**REGULAR MEETING OF THE
CITY OF CONCORD
DESIGN REVIEW BOARD**

REPORT TO DESIGN REVIEW BOARD

Project Name: Kamyshin Minor Hillside Development Use Permit and Design Review (PL150005-HM, DR)

Review Status: Preliminary Design Review

A2.1

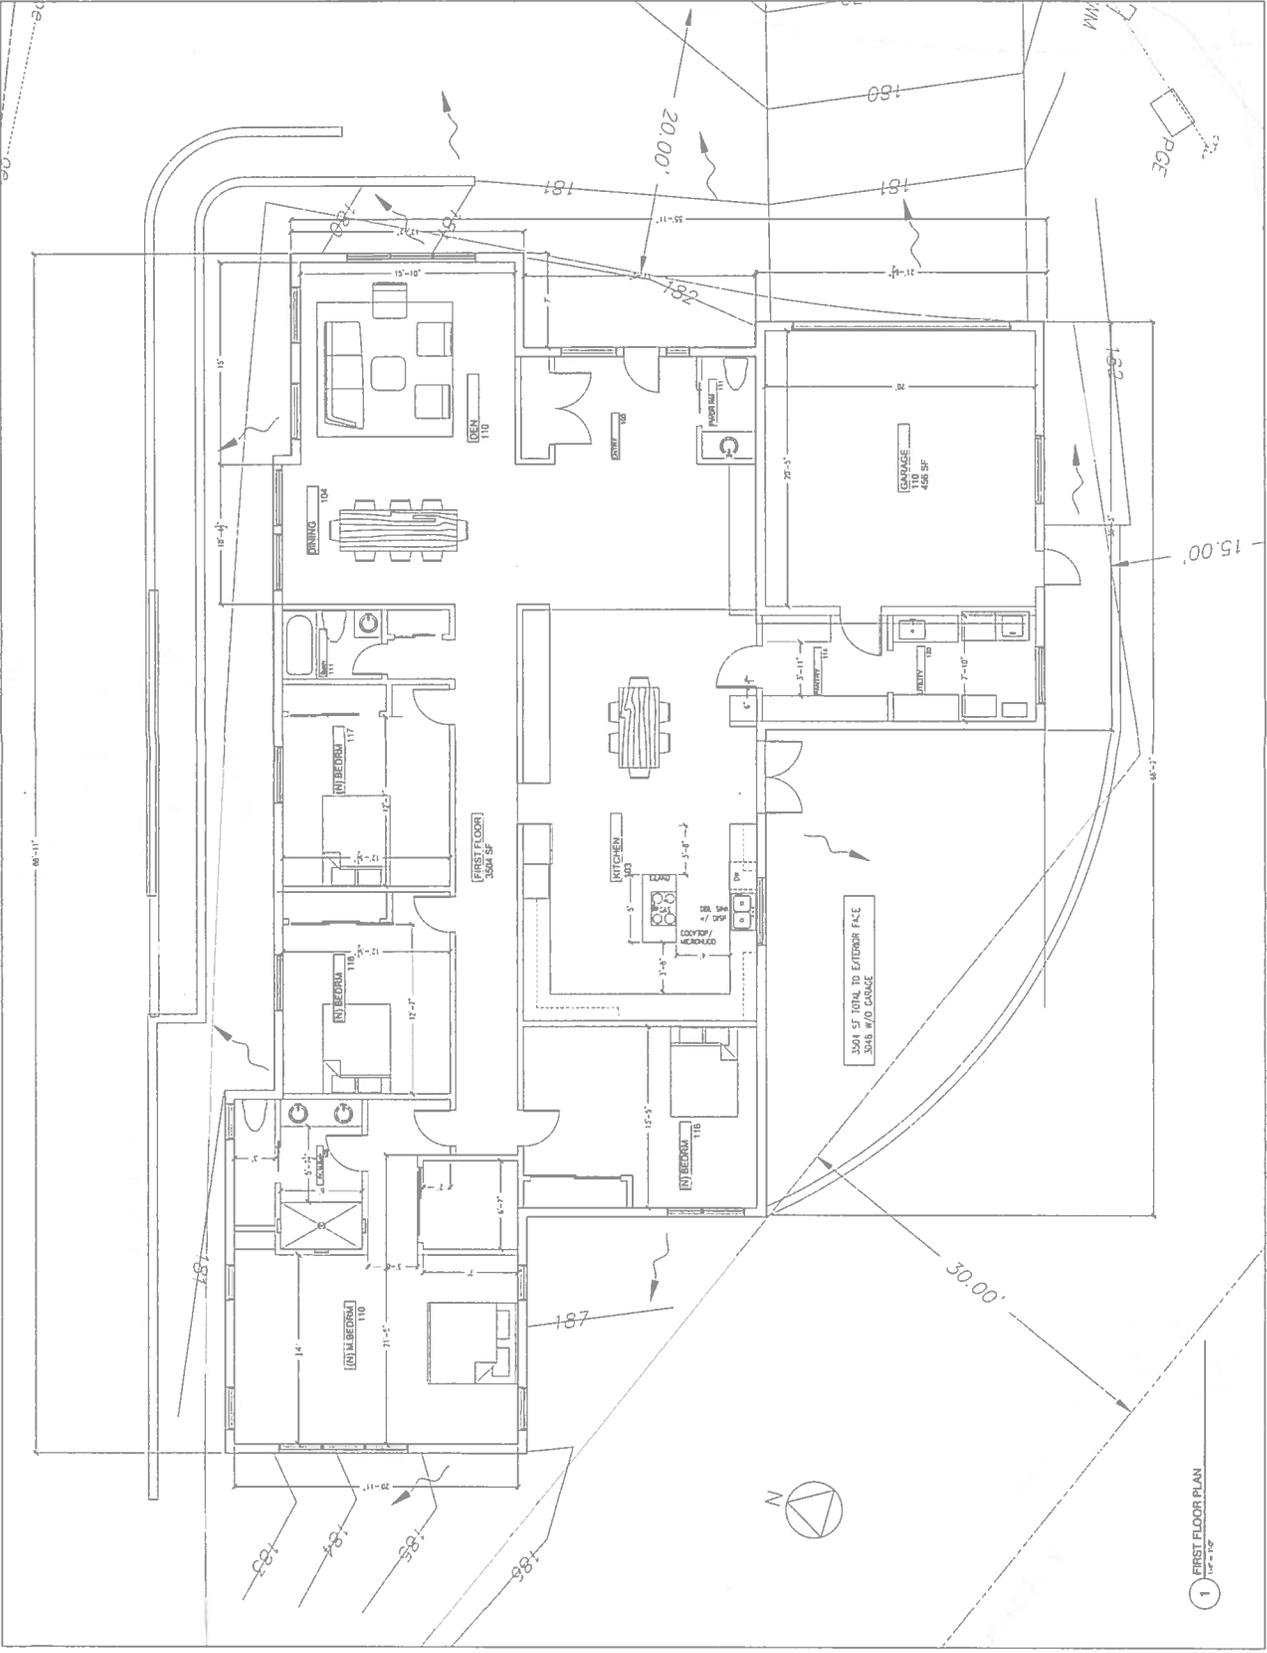
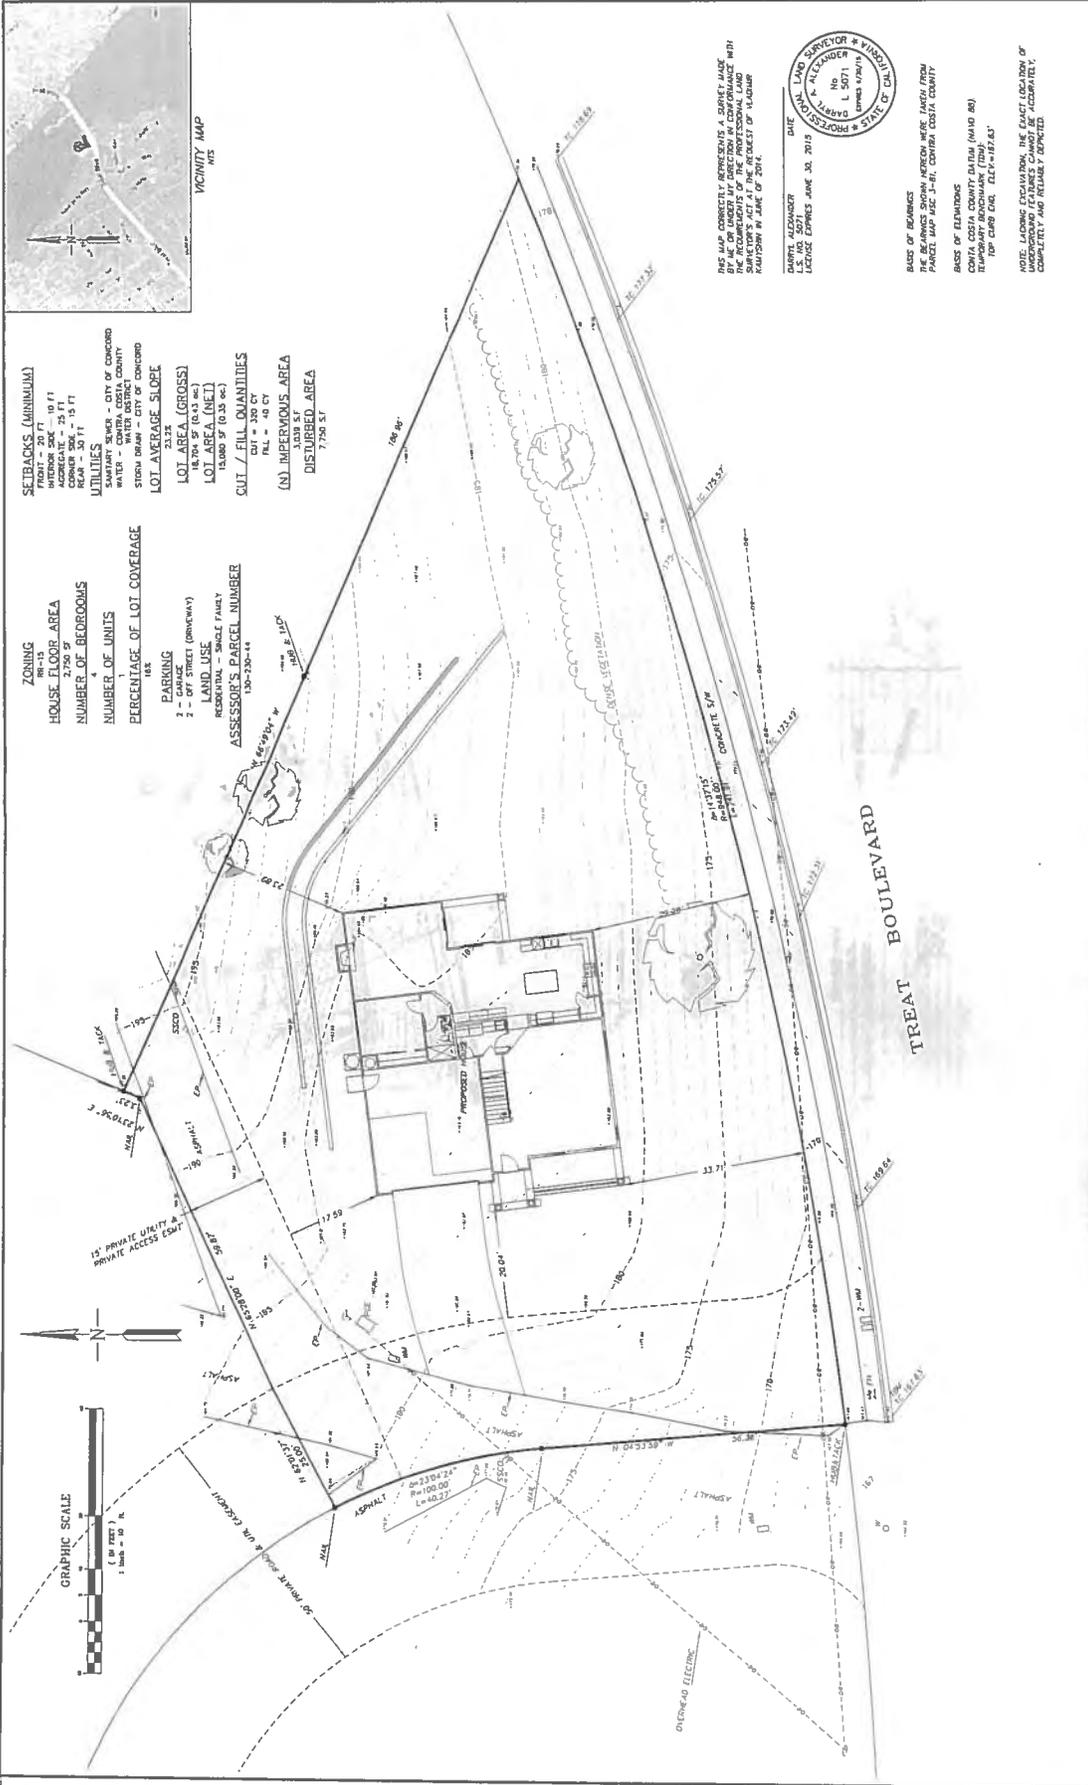
- *Re-examine the garage finish floor level to step pads to minimize flat grading, and improve the fit by better "nestling" home into hillside, such that design follows the topography.*

- *Consider a split-level foundation that follows the topography of the site with garage on separate level.*
- *Provide adjustable accent awnings of red western cedar on back windows of south elevation to improve screening of bedrooms from sun and reduce blank face of back portion of building (bedrooms).*
- *Update south elevation - Wood screen on south side of building is shown on front perspective but not for south elevation. Height of screen should be included.*

- *Re-examine the garage finish floor level to step pads to minimize flat grading, and improve the fit by better "nestling" home into hillside, such that design follows the topography.*

- *Consider a split-level foundation that follows the topography of the site with garage on separate level.*
- *Provide adjustable accent awnings of red western cedar on back windows of south elevation to improve screening of bedrooms from sun and reduce blank face of back portion of building (bedrooms).*
- *Update south elevation - Wood screen on south side of building is shown on front perspective but not for south elevation. Height of screen should be included.*
